PLANNING REPORT

Architectural Review Board

112 S. RIVERVIEW STREET 24-081MPR

Address	112 S. Riverview St, Dublin, OH 43017
Proposal	Proposal for modifications to a previously-approved home on a vacant lot in Historic Dublin.
Request	Review and approval of a Minor Project Review (MPR) under the provisions of Zoning Code Section 153.176 and the <i>Historic Design Guidelines</i> .
Zoning	HD-HR, Historic Residential District
Planning Recommendation	<u>Approval of Waivers</u> <u>Approval of MPR with Conditions</u>
Next Steps	Upon approval of the MPR from the Architectural Review Board (ARB), the applicant may file for Building Permits through Building Standards.
Applicant	Mandy Dyas, Epic Group Ohio
Case Manager	Rati Singh, Assoc. AIA, Planner I 614.410.4533 rsingh@dublin.oh.us

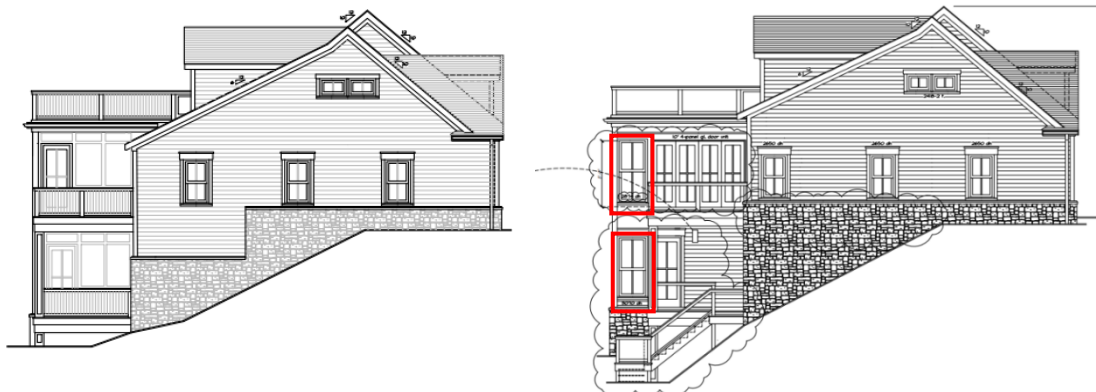
On the south decks on both floors, the applicant is now proposing five windows (highlighted in green), instead of the previously-approved door and window arrangement. Staff is supportive of the window arrangement on the first floor. Section 5.5(D)(C) of the *Historic Design Guidelines* recommends avoiding large surfaces of glass, and thus staff recommends retaining the previously-approved basement level elevation to maintain the anticipated balance between the materials. Per Section 5.6B of Guidelines, the window to wall ratio should be similar to other buildings in the district.

At the middle bay, the applicant has made internal changes to the layout and proposes removing two windows in the center (highlighted in blue), while leaving two wider windows with Hardie board panels in between. Staff recommends the previous window arrangement, which was purposely designed to look like a sunroom addition. A condition of approval addresses this. Should the Board opt to approve the newly-proposed window arrangement, then staff recommends that the top window proportions match those of the lower windows.

On the north deck, at the far right on the basement level, the proposal includes a mix of windows and doors instead of the previously-approved double doors to accommodate internal layout changes. The basement layout was not presented in the previous approval. The applicant also wants to change the door size to a wider one. The doors on the first and second floors (highlighted in red) were approved as the same size to ensure compliance with the Guidelines and minimize complexity. Staff recommends maintaining consistency in the opening sizes on the façade and suggests that the width of the doors be consistent. The proposed changes in door size are not due to any internal layout alterations. The Board had extensively discussed the window openings and made considerable efforts over four hearings to ensure that the Code and Guidelines were met before approving the application in July 2023, and thus staff is reluctant to support the proposed fenestration changes.

- 1) Applicant shall revert back to the left and rear (except at the first floor level, south deck and basement level, north deck) elevations as approved in July 2023
- 2) The windows on the right elevation highlighted in red shall be standardized prior to building permit.
- 3) The applicant shall change the Smooth-Star Shaker-style fiberglass single doors to Fir-Grain style at building permit.
- 4) The applicant shall provide staircase dimensions at building permit.
- 5) The applicant shall provide utility plans detailing the scope of work to be reviewed, approved, and inspected by Engineering, at building permit.
